Dockets Nos. 50-325  
and 50-324

The Commission has issued the enclosed Amendment No. <sup>24</sup> to Facility Operating License No. DPR-71 and Amendment No. <sup>48</sup> to Facility Operating License No. DPR-62 for the Brunswick Steam Electric Plant (BSEP), Units Nos. 1 and 2, respectively.

BRUNSWICK STEAM ELECTRIC PLANT, UNIT NO. 2

Amendment No. 48  
License No. DPR-62

MAXIMUM AVERAGE PLANAR  
LINEAR HEAT GENERATION RATE

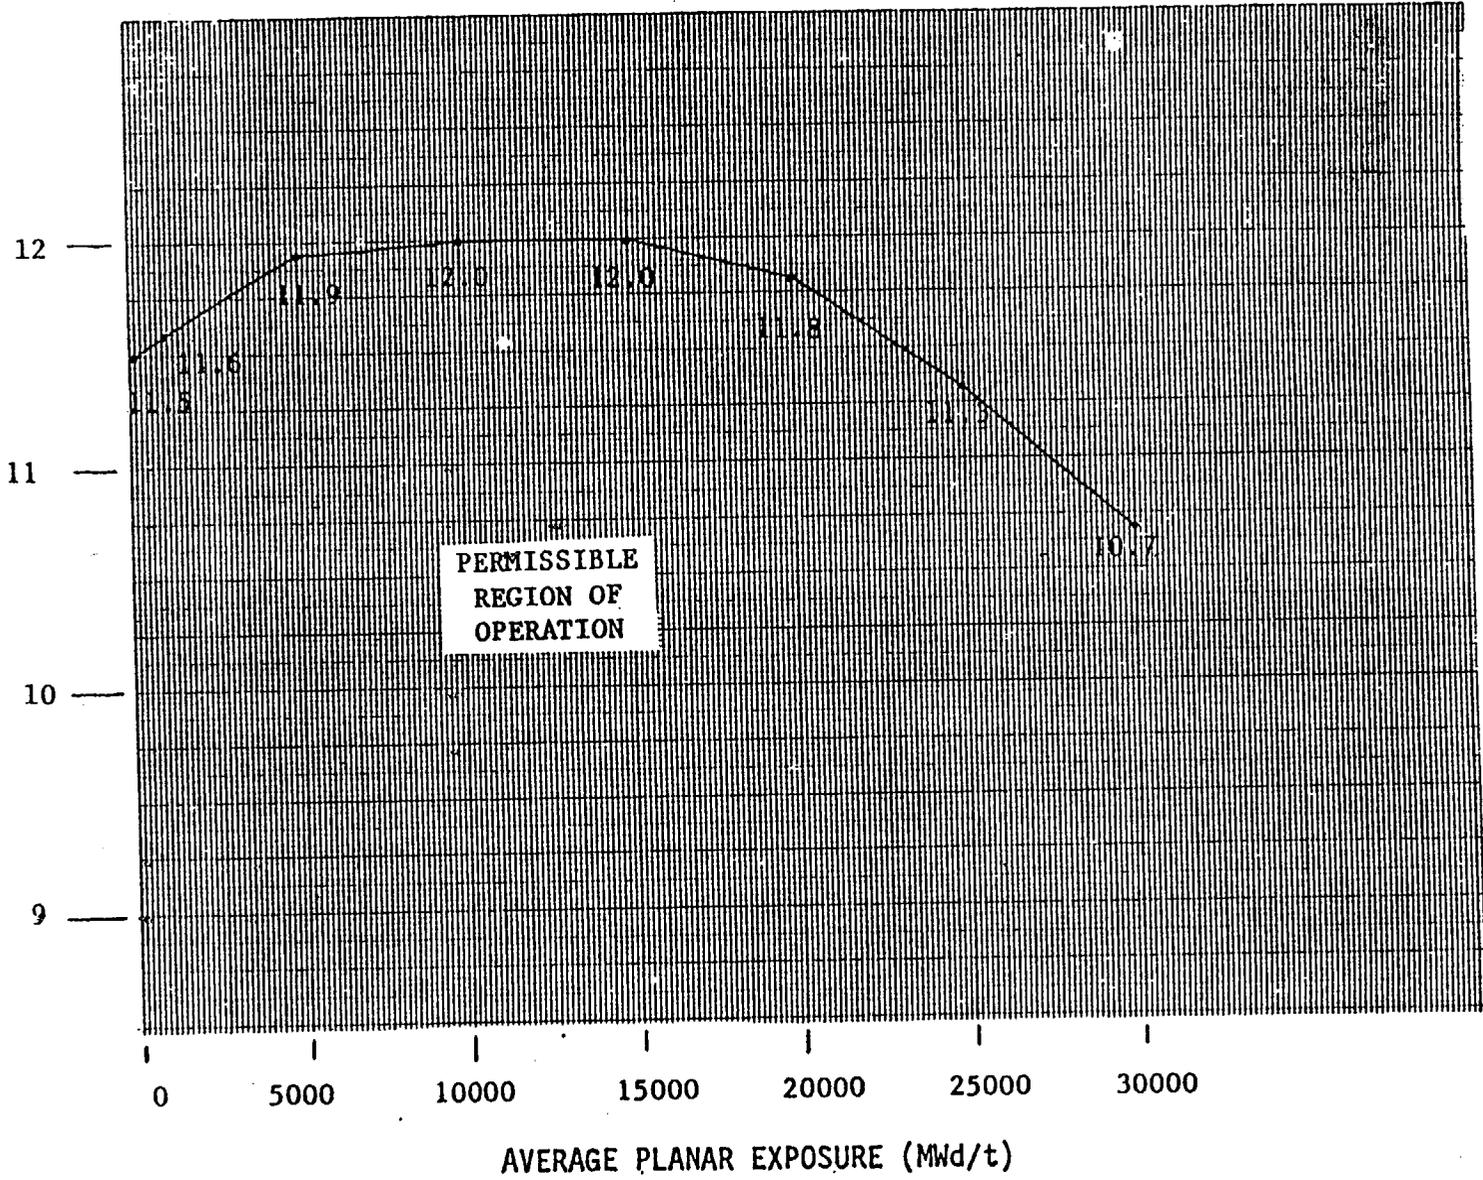
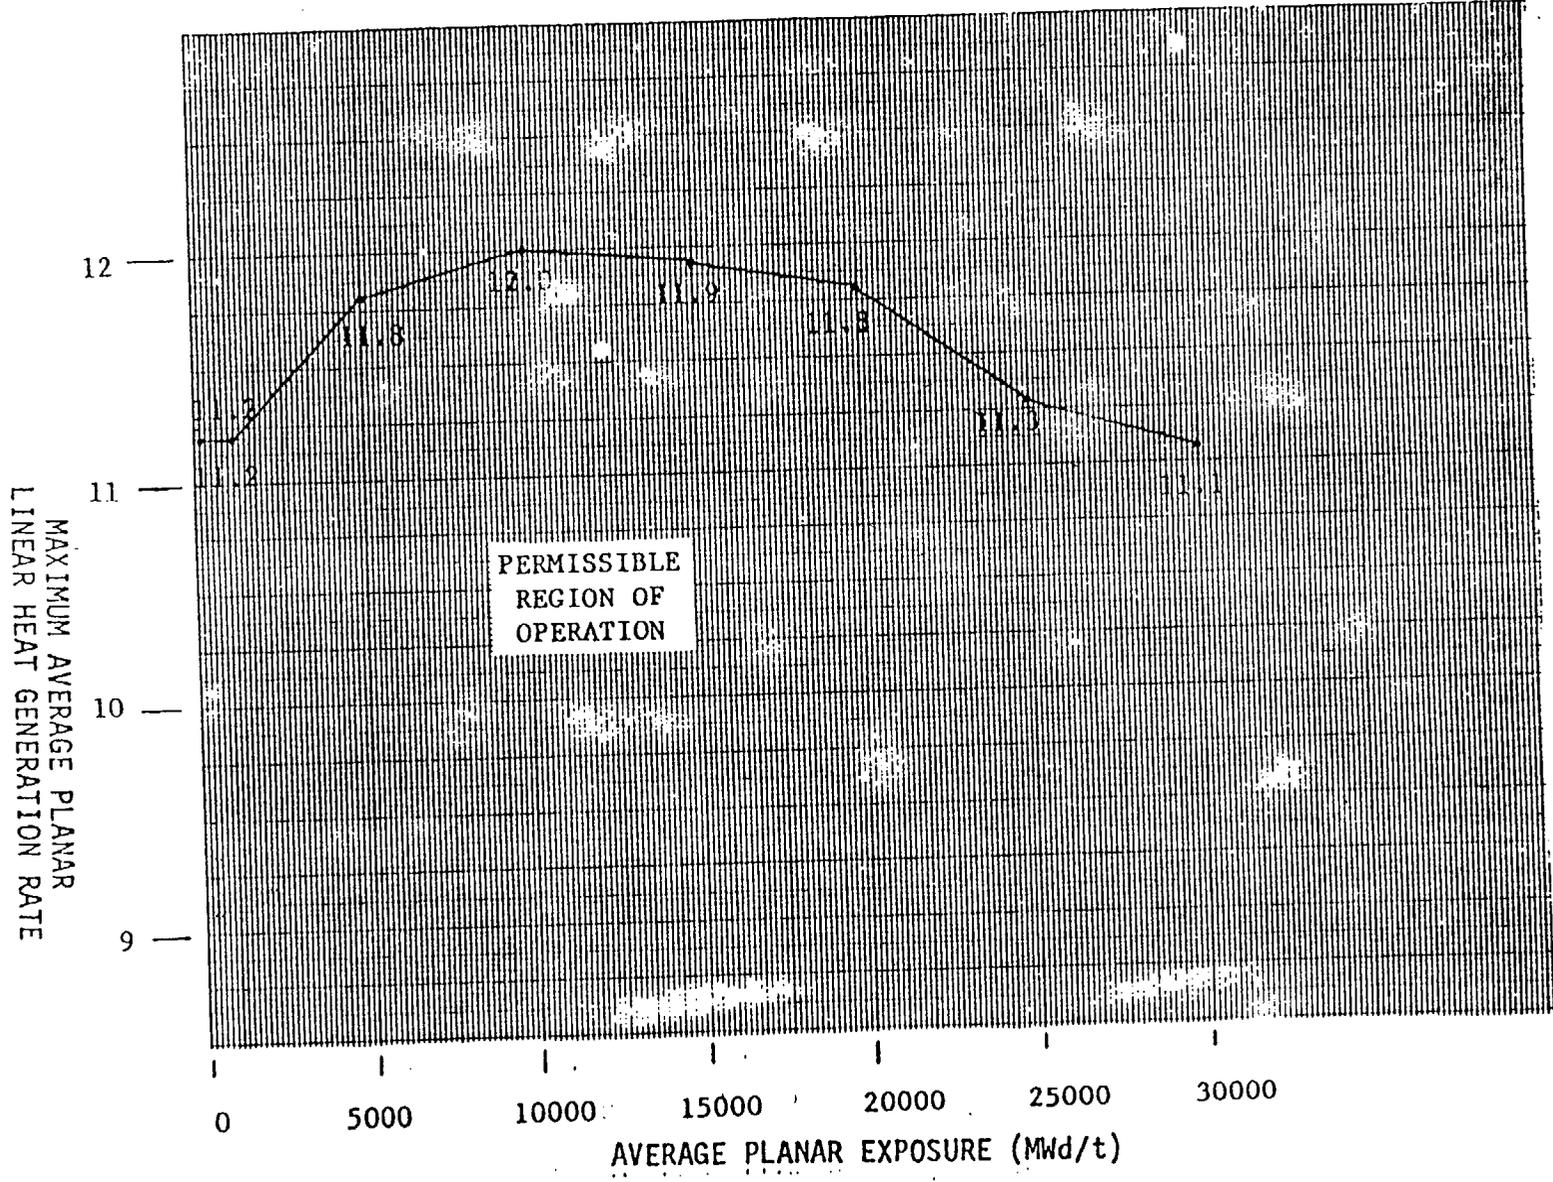
3.2.1 All AVERAGE PLANAR LINEAR HEAT GENERATION RATES (APLHGR's) for each type of fuel as a function of AVERAGE PLANAR EXPOSURE shall not exceed the limits shown in Figures 3.2.1-1, 3.2.1-2, 3.2.1-3, 3.2.1-4, 3.2.1-5, 3.2.1-6 or 3.2.1-7.

We have reviewed the information submitted by the licensee and conclude that all requirements of 10 CFR 50.46 and Appendix K to 10 CFR 50.46 will be met when the reactor is operated in accordance with the MAPLHGR versus Average Planar Exposure values given in Figures 3.2.1-1, 2, 3, 4, 5, 6, and 7 of the Technical Specifications.

FIGURE 3.2.3-1

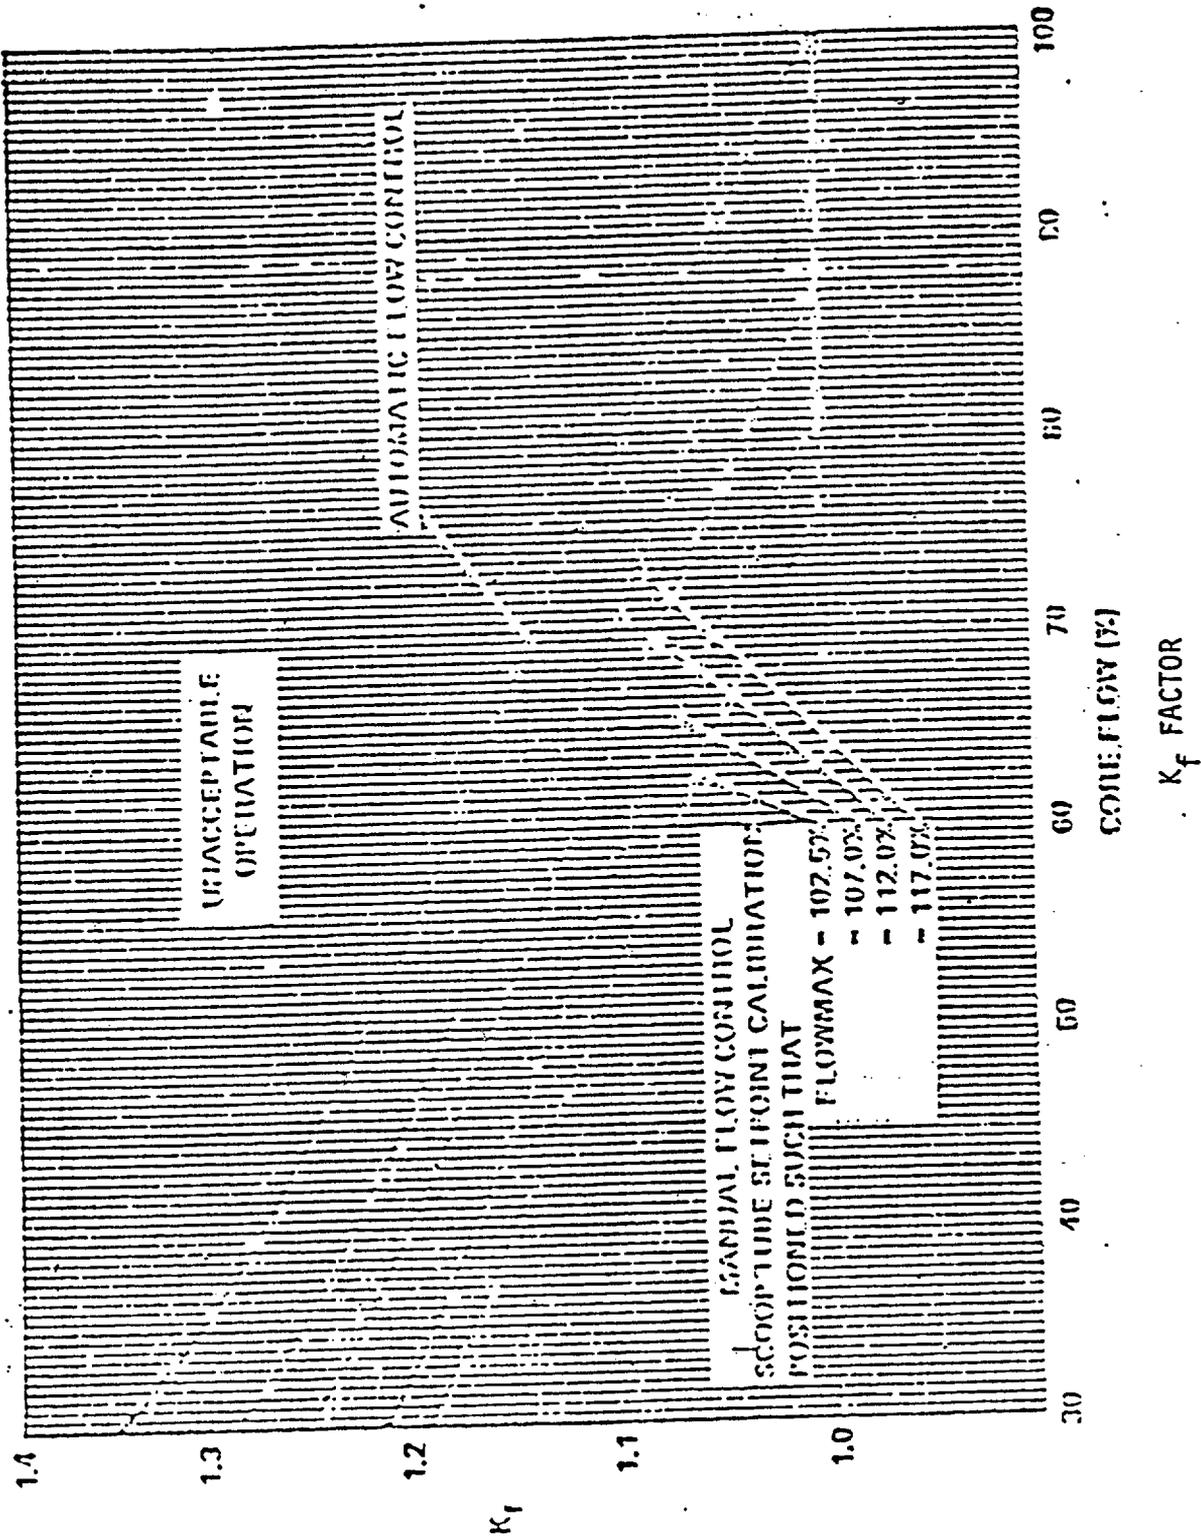
The  $K_f$  factor values shown in Figure 3.2.3-1 were developed generically which are applicable to all BWR/2, BWR/3, and BWR/4 reactors. The  $K_f$  factors were derived using the flow control line corresponding to rated thermal power at rated core flow.

The  $K_f$  factors shown in Figure 3.2.3-1 are conservative for the General Electric Plant operation with 8 x 8 and 8 x 8R fuel assemblies because the operating limit MCPR's of Specification 3.2.3 are greater than the original 1.20 operating limit MCPR used for the generic derivation of  $K_f$ . The  $k_f$  curves are conservative for 7 x 7 fuel whenever the operating limit MCPR is greater than 1.23 as documented in Appendix C of NEDE 24011-P-A. A correction to the  $K_f$  curves is, therefore, necessary whenever the MCPR for the 7 x 7 fuel is equal to or less than 1.23 in order to ensure that the fuel cladding integrity Safety Limit is not violated. This correction is made by using a scoop tube set point of 102.5%. The MCPR for 7 x 7 fuel is then the product of the value given in Specification 3.2.3 and the  $K_f$  curve based on 112% as shown in Figure 3.2.3-1. Whenever the MCPR for the 7 x 7 fuel is greater than 1.23, this correction is not applied.

\*For the 7x7 fuel, the 102.5% core flow  $K_f$  curve is nonconservative (Reference 6) with operating limits <1.23. Therefore, at reduced flow conditions, the  $K_f$  factor for the 7x7 fuel assemblies will be based on the 112% flow curve of Figure 3.2.2-1 of the Technical Specifications rather than the actual setpoint of 102.5%.
